## Stakeholder Comments Template

### Hybrid Resources Initiative: Straw Proposal

Submitted by	Organization	Date Submitted
<i>Nuo Tang 858-654-1818</i>	<i>San Diego Gas &amp; Electric Company</i>	<i>May 28, 2020</i>

AC connection metering layout for separate resource IDs –  
Both SCME and ISOME options are available.

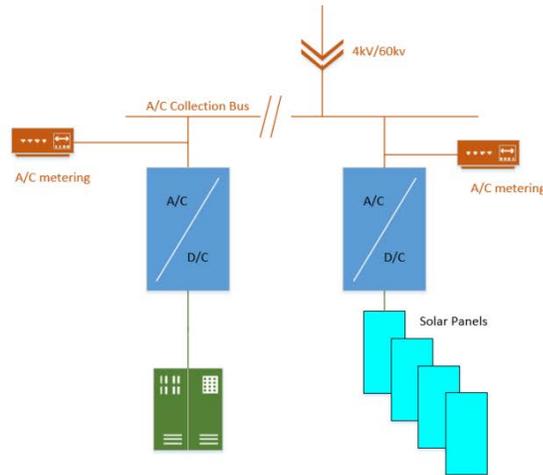
The CAISO provided a metering diagram of a co-located resource with two meters at the DC line for each component and another meter at the point of interconnection. SDG&E would like to understand whether the other metering layouts, such as the AC connection metering layout, detailed during the hybrid resource metering working group are also applicable.
